UNITED STATES PATENT AND TRADEMARK OFFICE

APPLICATION NO.	FILING DATE	FIRST NAMED INVENTOR	ATTORNEY DOCKET NO.	CONFIRMATION NO.
10/561,401	01/30/2006	Ilikka Naatti	TAMPPAT-17	1100
36528	7590	09/18/2008	EXAMINER	
STIENNONS & STIENNONS			CAMPOS, JR, JUAN J	
612 W. MAIN ST., SUITE 201				
P.O. BOX 1667			ART UNIT	PAPER NUMBER
MADISON, WI 53701-1667			3654	
			MAIL DATE	DELIVERY MODE
			09/18/2008	PAPER

Office Action Summary	Application No.	Applicant(s)	
	10/561,401	NAATTI ET AL.	
	Examiner	Art Unit	
	Juan J. Campos	3654

DETAILED ACTION

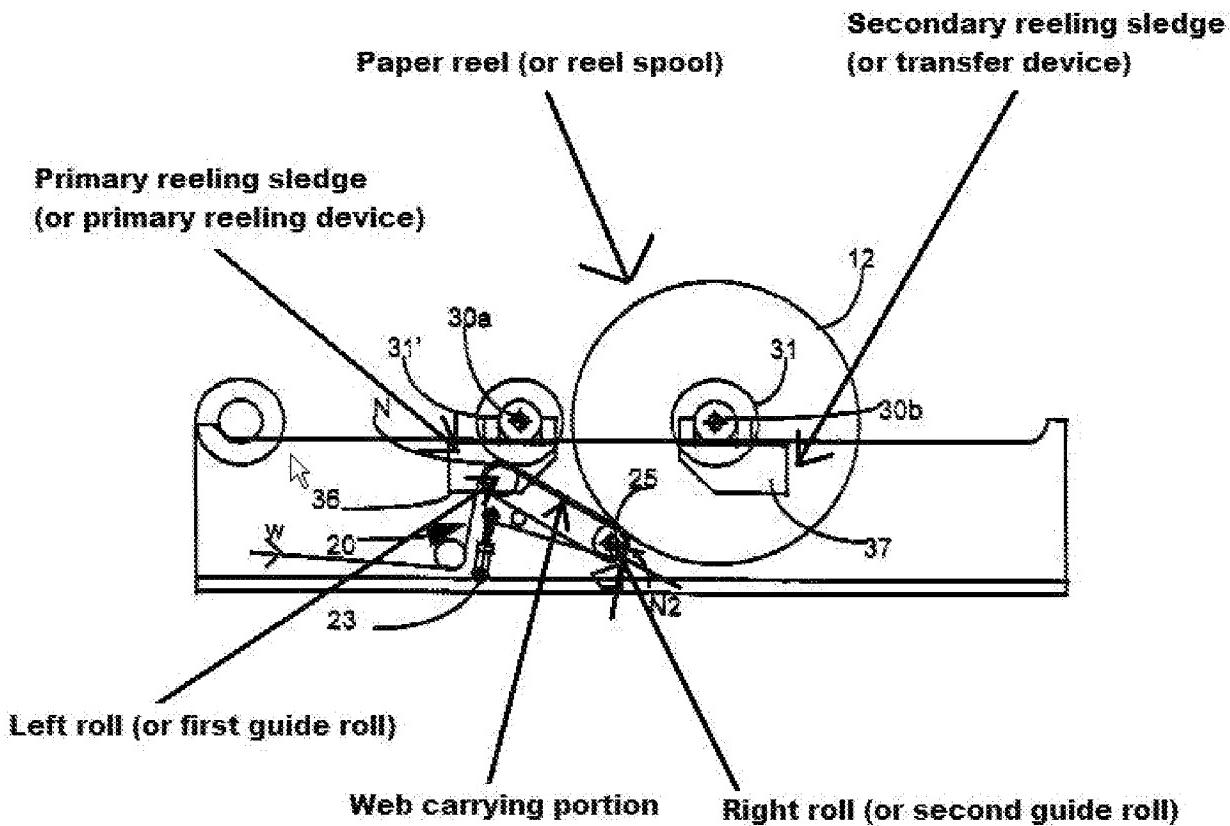
6. **Regarding claim 44,** Veräjäkorva (from here on just referred to as Verajakorva) discloses a reeling device and method in reeling of a paper web or equivalent that comprises a paper reel 12 (or reel spool having a spool axis, see figure a-d), and a primary reeling carriage sledge 36 (or primary reeling device) arranged to receive the paper reel, a belt (no number, see figures 1a-d, or supporting member) having an endless loop and inside the endless loop with a set of belt rolls (no numbers for the rolls, again see figures 1a-d) with at least a first roll (the left roll, or first guide roll) and a second roll (the right roll, or second guide roll), the endless loop having an upper web-carrying portion (no number) arranged to be driven in a machine direction (see belt in figure 1c) where the upper web-carrying portion forms a nip (see the nip between the paper reel 12 and left roll in belt in figure 1b), a nip positioned where the web W first joins the paper reel (see the nip in figures 1b-c) where the left roll (or first guide roll) is arranged so as to engage the paper reel with the web and the belt (with endless loop) there between before any other roll engages the paper reel and where the left roll (or first guide roll) is arranged to begin the reeling of the web on to the paper reel (or reel spool), further where the left roll (or first guide roll) is mounted for motion from a first position in nipping engagement with the paper reel (see figure 1b) to a second position against the incoming direction of the web (this second position occurs as the left-first guide roll is lowered by the hydraulic cylinder 23. Since the left-first guide roll does not move in a completely vertical direction, the left-first roll thus moves against the incoming

direction of the web, as the cylinder lowers that roll), a secondary reeling sledge 37 (or transfer device) is mounted for motion in the machine direction, and arranged to receive the paper reel 12 (or reel spool) from the primary reeling carriage sledge 36 (or primary reeling device) and move the paper reel 12 (or reel spool) in the machine direction so that the outer periphery of the paper reel remains in engagement with the endless loop during reeling of the paper on to the paper reel 12 (or reel spool). Also, see column 4 lines 59 through column 5 lines 67, and figure below.

Regarding claim 34, Verajakorva discloses a reeling device as discussed above in regarding claim 44. With the Verajakorva device above one can develop the method of reeling a paper web that comprise the steps of: bringing the web in an incoming

direction to the paper reel 12 (or reel spool), and reeling the web on to the paper reel 12 (or reel spool) to form a machine reel of increasing diameter in a primary reeling carriage sledge 36 (or a preliminary reeling station), the machine reel having a periphery and a peripheral direction defined as extending along the periphery of the machine reel, passing the web through a nip formed between an endless loop of the belt (or support member) and the machine reel (see figures 1a-d), wherein the endless loop (of the belt) is supported between the left roll (or a first guide roll) and the right roll (or a second guide roll) inside the endless loop where the left roll (or first guide roll) is positioned spaced against the incoming direction from the right roll (or second guide roll) where the paper web W first contacts the paper reel 12 (or reel spool) or machine reel while the web is engaged with the endless loop, wherein the left roll (or first guide roll) is defined as the roll which first comes into nipping engagement with the paper reel 12 (or reel spool), with the web and endless loop of the belt (or support member) there between, and wherein the left roll (or first guide roll) begins the reeling of the web on to the paper reel 12 (or reel spool) to form the machine reel, as the machine reel increases in diameter while still in the primary reeling carriage sledge 36 (or preliminary reeling station), moving an central axis defined by the left roll (or first guide roll) in the peripheral direction and against the incoming direction (this second position occurs as the left-first guide roll is lowered by the hydraulic cylinder 23. Since the left-first guide roll does not move in a completely vertical direction, the left-first roll thus moves against the incoming direction of the web, as the cylinder lowers that roll), and transferring the machine reel away from the primary reeling carriage sledge 36 preliminary reeling

station in the incoming direction i.e., a machine direction, in a secondary reeling sledge 37 (or transfer device) forming a secondary reeling station (the location of the secondary reeling sledge when paper reel has transferred the secondary reeling sledge, see figure 1d), the secondary reeling sledge (or transfer device) mounted for motion in the incoming direction so that the machine reel continues to form the nip through which the web passes until reeling of the machine reel is finished. The method of operating the apparatus is well known and no new, non-obvious or improvement claims are described by the method claim since all elements of the Verajakorva apparatus are disclosed in detail above. Also, see column 4 lines 59 through column 5 lines 67 and figure above.
